NATIONAL CAPITAL DESIGN REVIEW PANEL

Block 12 and 15 Section 49 Kingston – First Session

Kingston Arts Precinct – Estate Development Plan (EDP)

Date issued: Wednesday 27 September 2023

Study 2 - 3D Massing

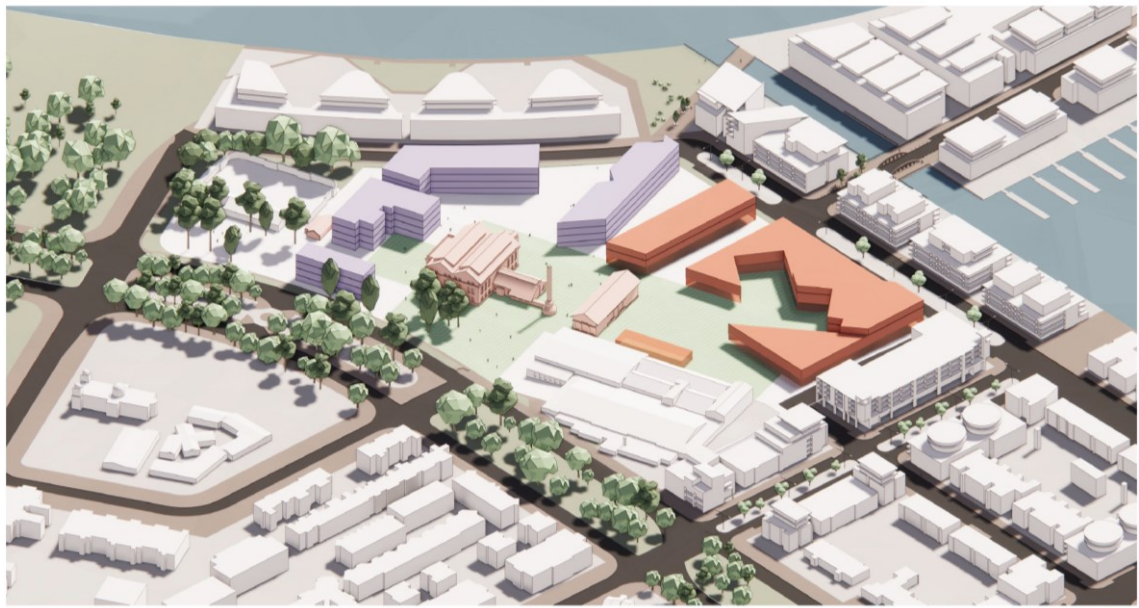
In addition to further contextual analysis, the proponent is encouraged to test the concept designs to ensure the public domain and individual buildings are fit for purpose in terms of the functionality and amenity delivered. The Panel is concerned that the preferred concept (Option 2) is yet to demonstrate that the site planning and individual building footprints are capable of delivering the pragmatic elements required to support the functioning of the precinct, including traffic, waste, logistics for materials and events, wayfinding and accommodation for landscape including canopy trees.

5.4 Explore how car parking may be sensitively integrated within the precinct, including through ‘sleeving’ of the car park with active uses and/or through marrying of one or more arts organisation buildings with the parking structure.

PROPONENT RESPONSE	UPDATED PLAN
The project explored three new approaches to above ground parking which was seeking to deliver excellent urban design outcomes while balancing financial imperatives. Option A placed the multideck structure between the precinct's major plaza and land release parcels, acting as a buffer between public and more private areas in the precinct. The ground plane is sleeved on three sides to activate the public realm, with the deck above stacked to accommodate future potential adaptive reuse. Overall parking loads are relatively evenly distributed between both the Eastlake Parade / Wentworth Avenue and Giles Street / Wentworth Avenue intersections. Option B placed the multideck structure to the south of the Fitters Workshop, providing direct access to Printers Way. Consequently the major plaza is framed on one side by land release development that would need to be sensitively managed, and poses significant acoustic challenges for the activation of the public realm. Additionally, the precinct's HV cable would need to be partially relocated, and more traffic is funnelled into the Giles Street / Wentworth Avenue intersection. The extent of land release results in a denser aggregation of arts buildings when compared with Option A. Option C located public parking in two levels of basement below the major plaza (as per the original concept studies), as well as off-site in a separate location approximately 500m south of the precinct. Like Option B, the major plaza is framed on one side by land release development that would need to be sensitively managed, and poses very significant acoustic challenges for the activation of the public realm. It eliminates the visual bulk of an above-ground structure, but releases more land for future use, resulting in a denser aggregation of arts buildings. The Design Team notes that a more aggressive planning approach could yield a significant reduction in public car parking needs. This would moderate all options, but in particular provide greater flexibility in the resolution of the Option A sleeved car park by exploring more arts programming in the building and a smaller overall footprint, well offset from the Powerhouse.

The selected Concept adopts Option B as a carpark solution. Refer Section 5.2 for additional commentary.
